**From:** "Tellina Finlay" <Tellina@northpointplanning.com.au>  
**Sent:** Fri, 19 Dec 2025 11:50:06 +1000  
**To:** "Development Assessment" <developmentassessment@townsville.qld.gov.au>;  
"Taryn Pace" <taryn.pace@townsville.qld.gov.au>  
**Cc:** "Meredith Hutton" <meredith@northpointplanning.com.au>  
**Subject:** NP24.264 | MCU25/0067 - Information Request Response - Material Change of Use – Multiple Dwelling (12 Units) at 9-13 Milne Street, Idalia  
**Attachments:** ONP24.264 - Information Request Response.pdf

**Response to Information Request**  
**Development Application for Material Change of Use – Multiple Dwelling (12 Units)**  
**9-13 Milne Street, Idalia and formally identified as Lot 1 on RP746628**

## Information Request *Planning Act 2016*

Application no:	MCU25/0067
Assessment no:	3202003
Proposal:	Multiple Dwelling
Street address:	9-13 Milne Street IDALIA QLD 4811
Real property description:	Lot 1 RP 746628
Applicant's reference:	NP24.264

3 3D View

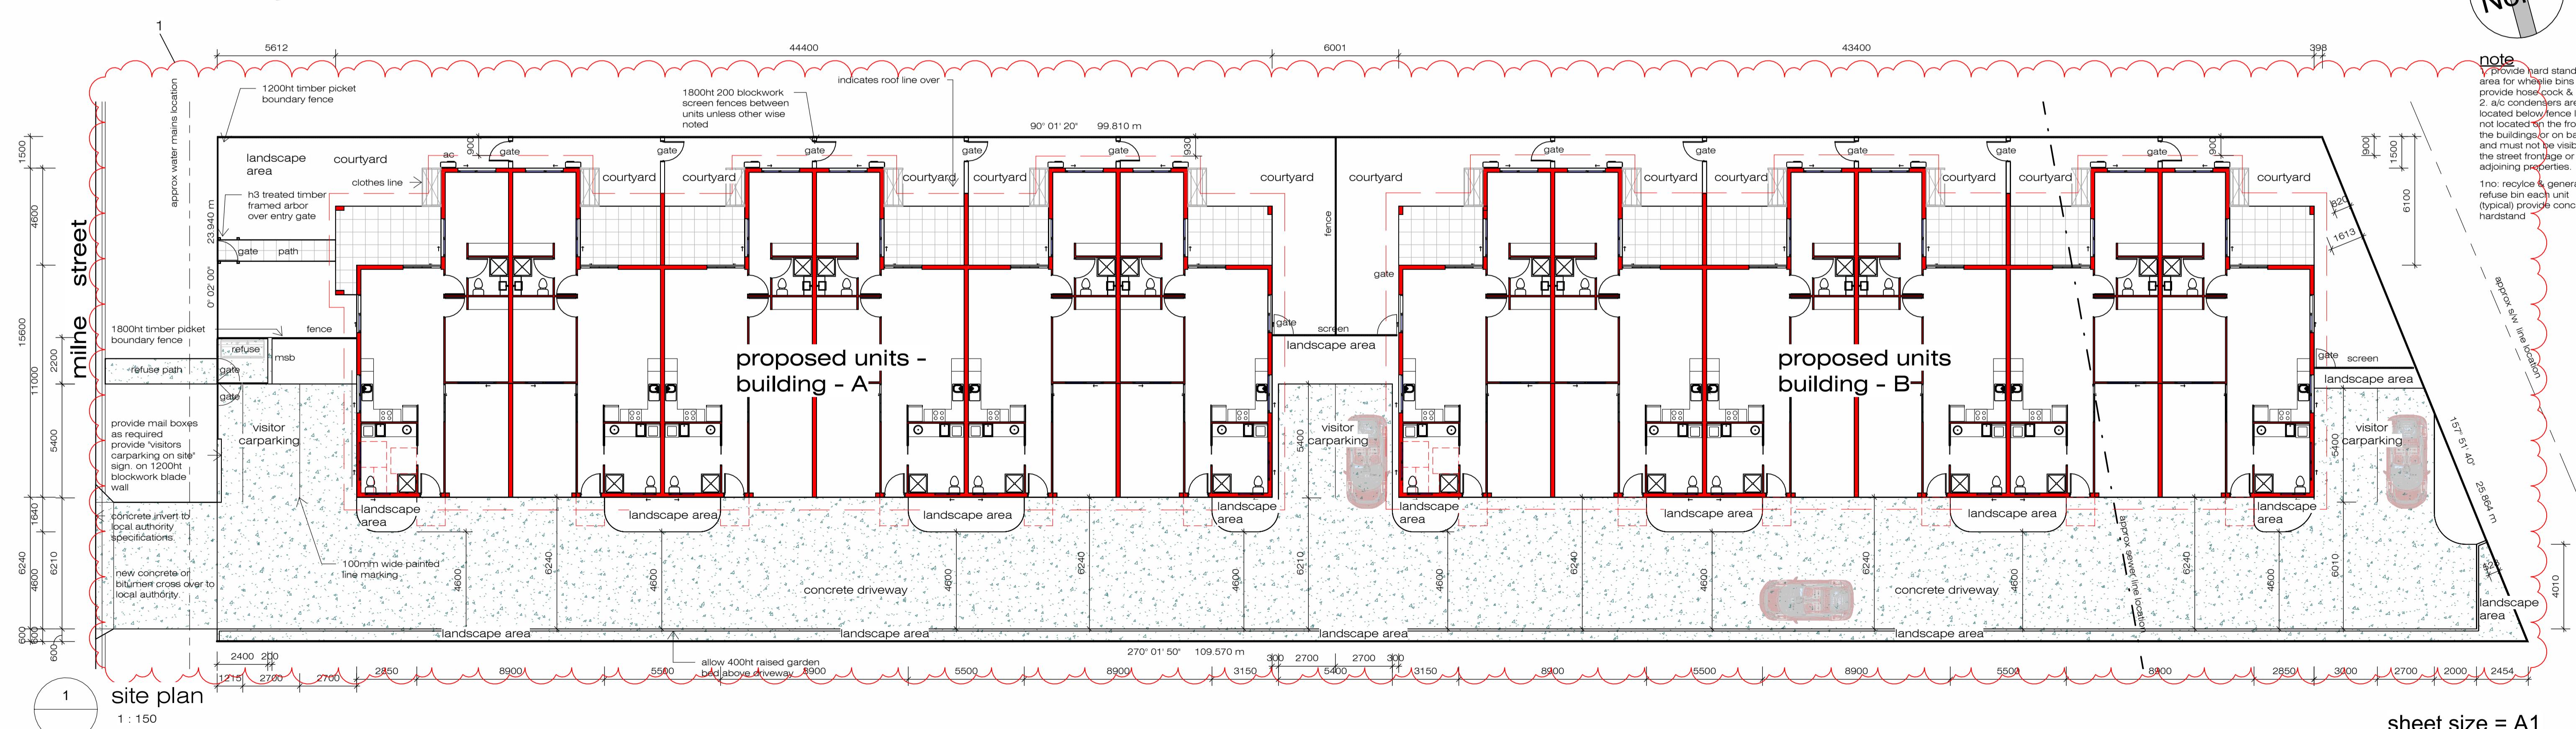
- *Improved interface and engagement with the Milne Street frontage, including, but not limited to:*

- *Reorientation of 'Units 1 and 2' to present the primary façade of these dwelling units to the road frontage;*
- *Modulation and variation in the form and materials of the street facing façade of the reoriented dwelling units;*
- *Separate, visible building entrances from the Milne Street frontage to any dwelling units along this frontage; and*
- *Clear pedestrian pathway access (including a structure or gateway) from Milne Street that is separate from the drive*
- *Modulation and variation in roof form and materials to highlight the entry points of each unit;*
- *A minimum 1.5m wide densely planted landscape buffer along the full southern boundary of the site.*

- Improved interface and engagement with the Milne Street frontage, including, but not limited to:
  - Reorientation of 'Units 1 and 2' to present the primary façade of these dwelling units to the road frontage;
  - Modulation and variation in the form and materials of the street facing façade of the reoriented dwelling units;
  - Separate, visible building entrances from the Milne Street frontage to any dwelling units along this frontage; and
  - Clear pedestrian pathway access (including a structure or gateway) from Milne Street that is separate from the driveway, and connects to an internal pedestrian pathway to the entry of each unit.
- Modulation and variation in the roof form and materials to highlight the entry points of each unit;

- Removal of the screening to the northern side of the Milne Street frontage, reducing built-form obscurity.
- Provision of a projecting asymmetrical gable to the Unit 1 patio with design reflective of a single detached dwelling entranceway, improving visual interest and amenity from the streetscape.
- 0.6m wide landscape buffer traversing the full extent of the southern property boundary, with the area of existing proposed landscaping increased.
- Provision of a pedestrian pathway and access gate to the northern side of the Milne Street frontage, contributing to active frontage and connectivity.

The proposed design amendments have been included to provide for improved active frontage, streetscape perspective and residential amenity, with these changes considered suitable in reflecting Council's desired outlook and functionality for the proposed Multiple Dwelling.

Figure 1 – Developed scenario DEM

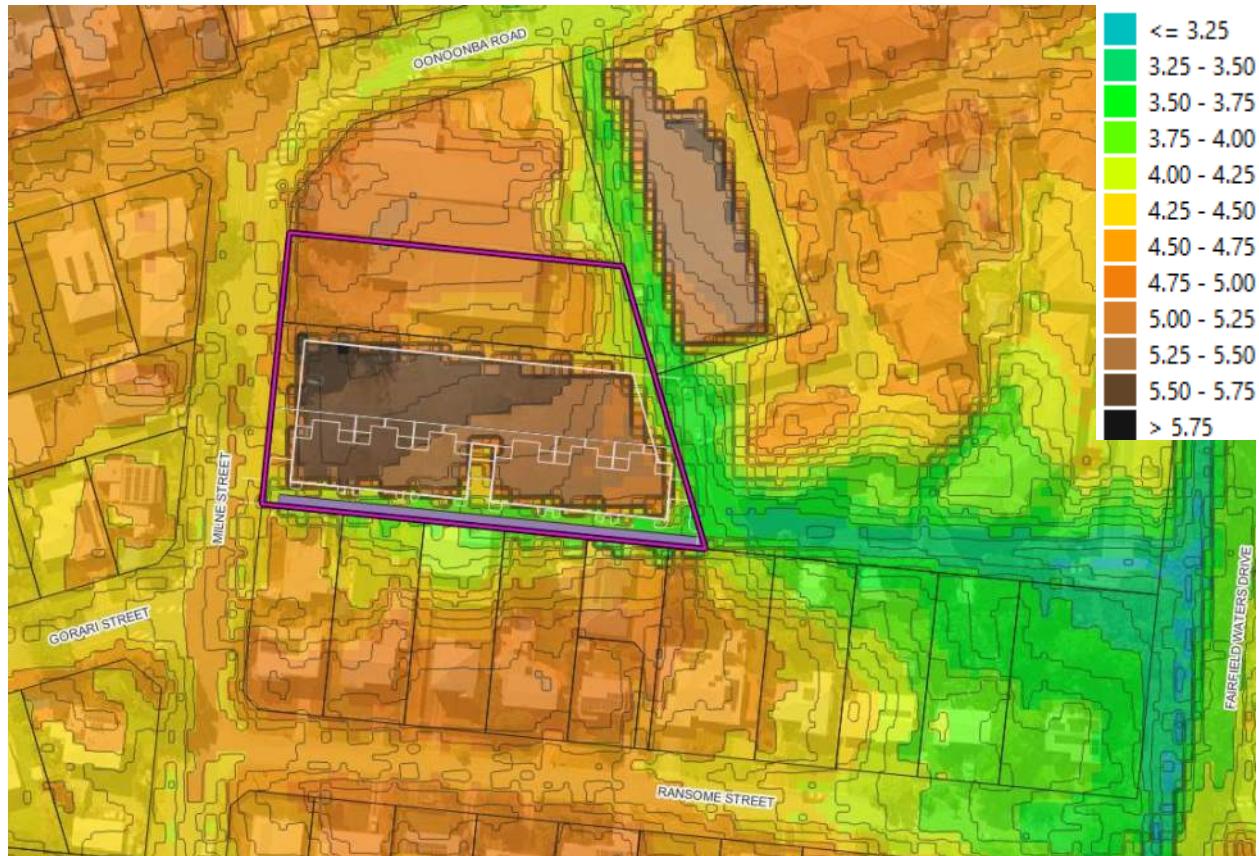
- *1% AEP offsite afflux to be reduced. Afflux plot A01 shows 20-30mm of afflux around existing buildings on adjoining lots, and 10-20mm extending >50m from the site; and*
- *Blockage sensitivity analysis requested for the inlets along the common boundary with the Ransome Street properties.*

- 1% AEP offsite afflux to be reduced. Afflux plot A01 shows 20-30mm of afflux around existing buildings on adjoining lots, and 10-20mm extending >50m from the site; and
- Blockage sensitivity analysis requested for the inlets along the common boundary with the Ransome Street properties.

- The development extent, including an area on the adjoining land parcel to the north, have been raised to be flood immune. The 'filled' area on the adjoining land parcel was setback ~6.4m from the

front boundary, ~4m from the northern boundary and ~5.3m from the rear boundary. Refer Figure 1.

- There is a significant flow path along the southern boundary, where the driveway is proposed, and when this area was filled, significant afflux was observed. This was resolved by modelling a suspended driveway that had a flow area of ~2.8m x 0.7m under the driveway slab, refer Figure 2. To represent this, two (2) bridge structures were modelled using the 2d\_lfcsh line and region shape files. The region file (the pink area illustrated along the southern boundary in Figure 1) was applied for the full length of the driveway for the 2.8m width in order to allow flow from the southern property to flow underneath the driveway. The blade walls were simulated as piers at 5% blockage factor with the driveway slab simulated as 100% blockage factor. The line file was applied on the western end region file with a blockage factor of 50% applied to represent a 2.8m wide x 0.6m high grated inlet that allows water underneath the driveway. The ground under the driveway was regraded, starting at ~RL4.08 at the front boundary to ~RL3.68 at the rear.

Figure 2 – Suspended driveway concept

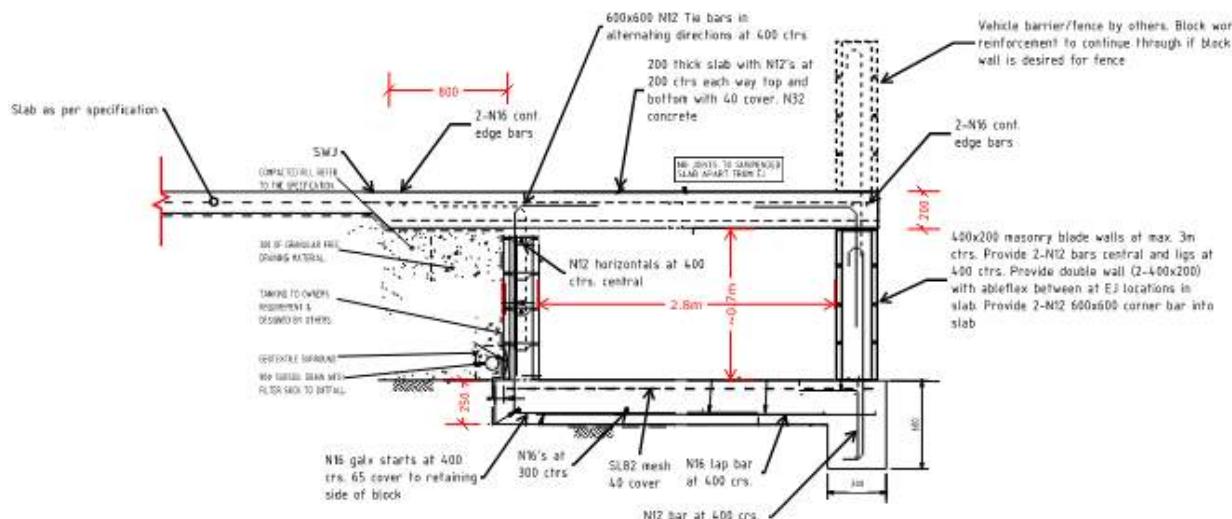
This request item requires the applicant to provide amended plans providing further details of the driveway, including:

- *An increase in width to accommodate two-way vehicle movements;*
- *Vehicle swept paths demonstrating that resident and visitor parking spaces can be safely utilised, and that safe, two-way passing movements can occur;*
- *The location and design of proposed mailboxes to ensure sight lines at the property boundary comply with AS280.1;*
- *Development plans demonstrating the proposed suspended slab arrangement. A section is requested to be provided along the southern site boundary showing the inlets proposed to accept runoff from the Ransome Street properties; and*
- *Confirmation of setback distance of the suspended driveway from the southern boundary to ensure maintenance access to the inlets can be achieved.*

- An increase in width to accommodate two-way vehicle movements;
- Vehicle swept paths demonstrating that resident and visitor parking spaces can be safely utilised, and that safe, two-way passing movements can occur;
- The location and design of proposed mailboxes to ensure sight lines at the property boundary comply with AS280.1;
- Development plans demonstrating the proposed suspended slab arrangement. A section is requested to be provided along the southern site boundary showing the inlets proposed to accept runoff from the Ransome Street properties; and
- Confirmation of setback distance of the suspended driveway from the southern boundary to ensure maintenance access to the inlets can be achieved.

In response to this item, the proposed development plans have been amended to enhance vehicle ingress and egress, internal manoeuvring, and overall safety, while retaining the proposed parking layout. Key amendments include a 0.6m shift of the built form to the north, which has increased the driveway width along the southern boundary. This adjustment improves vehicle access and spatial efficiency within the site.

The refuse storage area has also been consolidated into a single, screened bin enclosure located to the western boundary of the site. This modification not only simplifies waste collection but also frees up space for additional landscaping at the unit entrances and improves the overall amenity of the proposed design. Mailboxes are nominated along the northern side of the driveway, integrated with a blockwork blade wall to maintain visual amenity at the frontage.

The proposed driveway varies in width between 4.6m and 6.24m. While a consistent 6m wide driveway is not provided along the full length, the design incorporates landscaped areas that double as functional turn-out bays. These areas allow an entering vehicle to pause safely where necessary to allow an exiting vehicle to pass, effectively managing any infrequent instances of conflicting vehicle movement without compromising safety or functionality.

Given this configuration and the low volume of vehicle movements anticipated for the proposed development, the access design is considered appropriate and capable of supporting efficient two-way vehicle movement. As such, formal swept path diagrams are not considered necessary in this instance.

Refer to Figure 2 – Suspended Driveway Concept within the Flood Impact Assessment (**Attachment 3**) for illustration of the driveway design.
